SUBJECT: NuScale Power, LLC Response to NRC Request for Additional Information No. 9224 (eRAI No. 9224) on the NuScale Topical Report, "Accident Source Term Methodology," TR-0915-17565, Revision 2

Response to Request for Additional Information

eRAI No.: 9224

NRC Question No.: 01.05-32

Figure 2: Baseline case aerosol concentration and removal

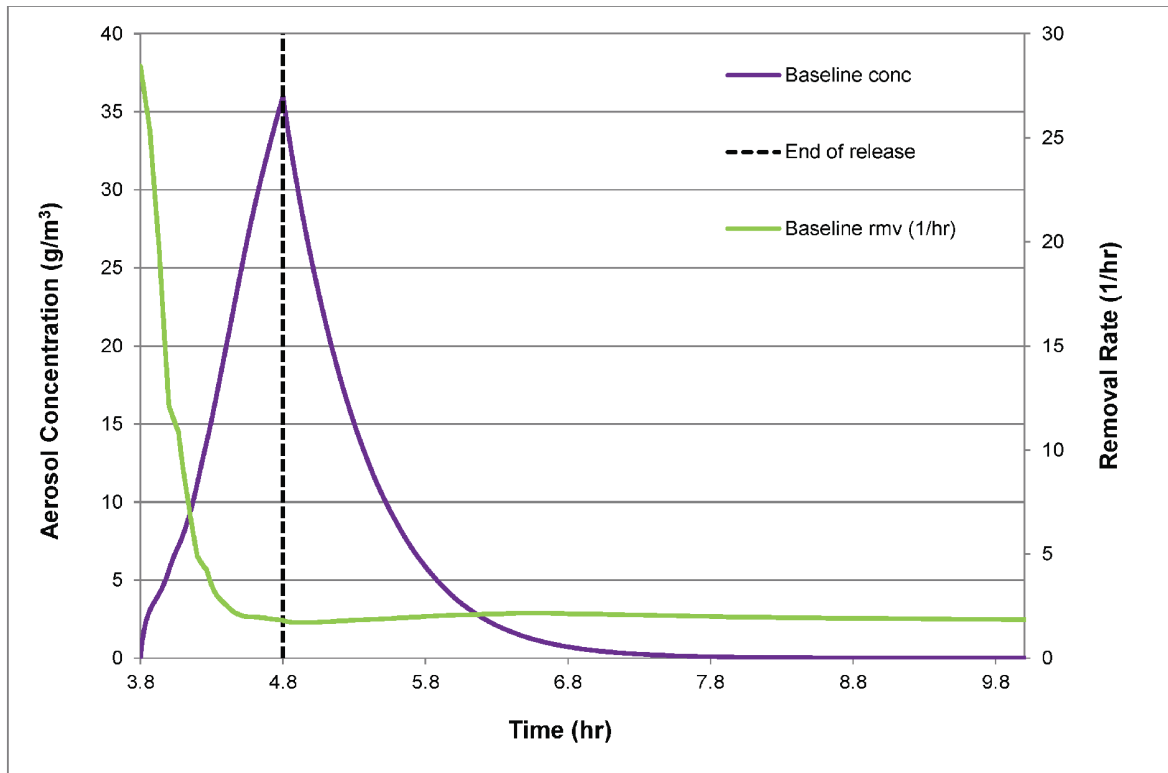
4. With respect to the example implementation of the methodology on aerosol removal, the two curves (aerosol concentration and aerosol removal rate constant) in Figure 5-13 of the TR appear to be inconsistent with each other. For the period beginning at the end of the release, the decrease in the aerosol concentration has a lower removal rate than shown in the removal rate constant curve. Please clarify this apparent inconsistency and how the curves were calculated.

4. Figure 5-13 of TR-0915-17565-P, Rev. 2 was in error because of an internal post-processing error in the STARNAUA software. The vendor has been notified and the error has been addressed. NuScale will update Figure 5-13 and other associated STARNAUA example results in TR-0915-17565-P, Rev. 3. Figure 2 of this RAI response shows Figure 5-13's replacement that will be incorporated into TR-0915-17565-P, Rev. 3.
